**Record of Decision**  
**Photocircuits Corporation**  
**Operable Unit No. 1**  
**City of Glen Cove, Nassau County, New York**  
**Site Number 130009**

**March 2008**

# **DECLARATION STATEMENT - RECORD OF DECISION**

This responsiveness summary responds to all questions and comments raised during the public comment period. The following are the comments received, with the Department's responses:

Figure 4  
Remedial Area  
Bioremediation with  
Air Sparging Curtain

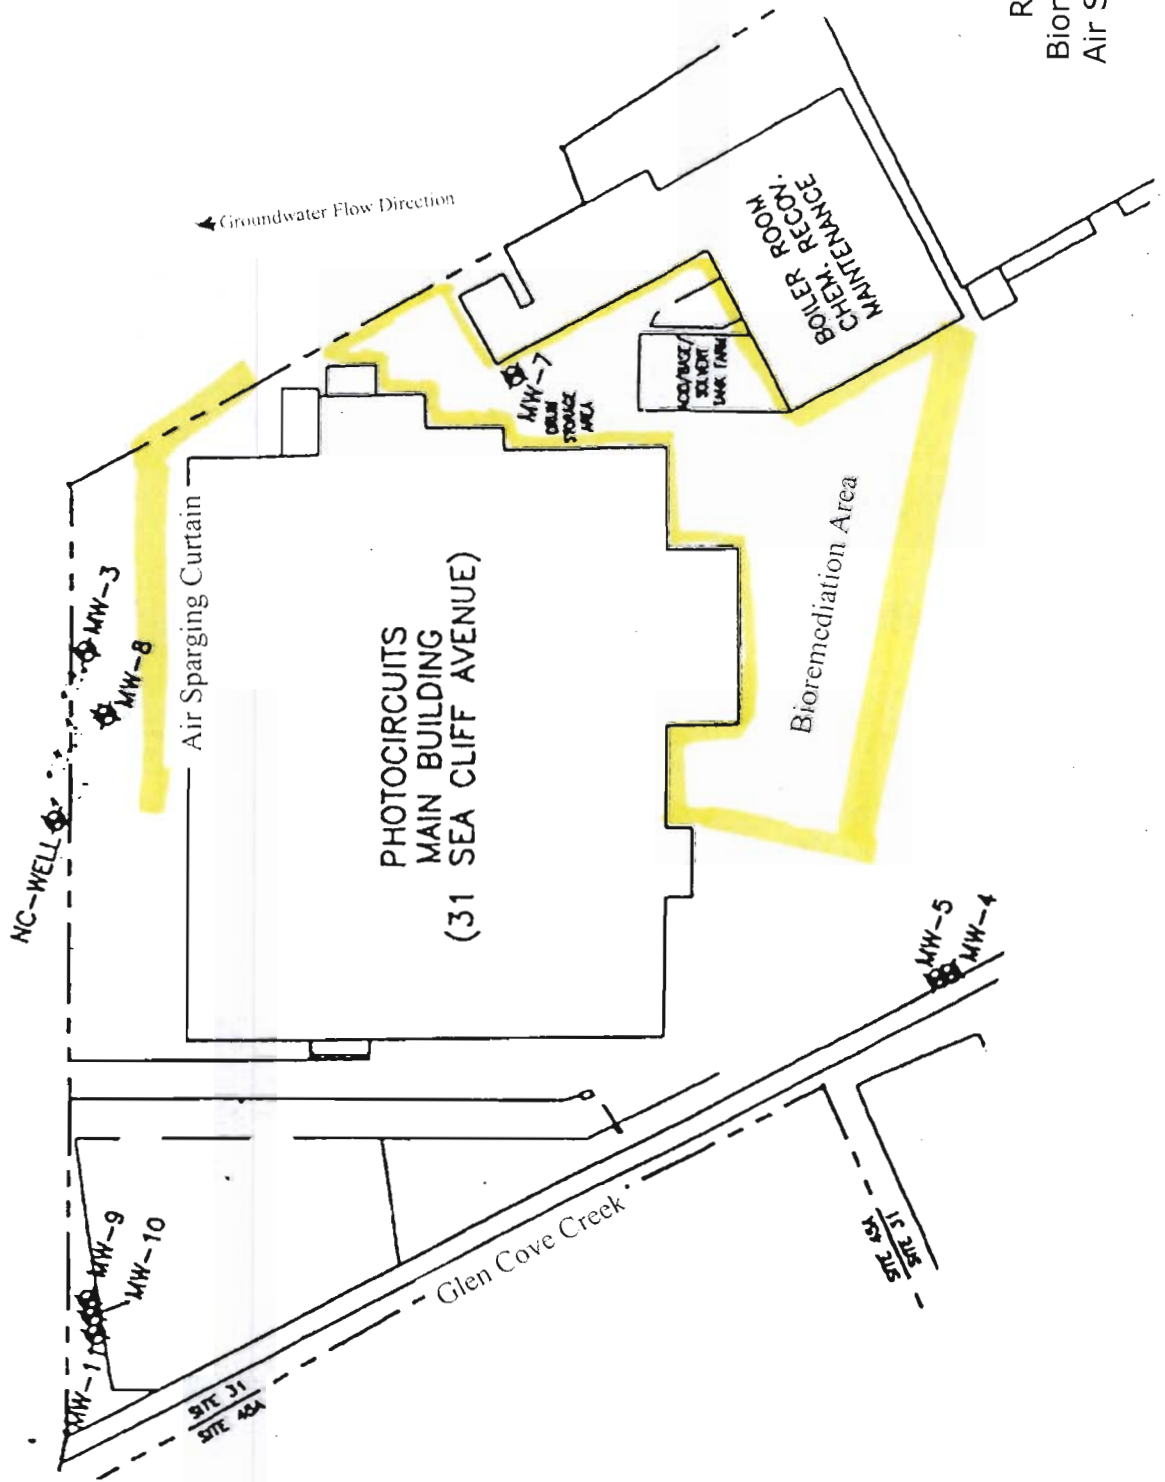
- COMMENT 6:** A nearby building owner was concerned about inhalation of contaminants during the air sparging. How can my building be checked to make sure it is safe?

- RESPONSE 6:** The remedial action provides for air sparging at the downgradient property boundary and provides for soil vapor sampling to evaluate if vapors are being generated by this process. A safeguard in place is the contingent soil vapor extraction requirement in the ROD. If vapors are detected, the NYSDOH will evaluate if there is potential for vapors to migrate to other structures.
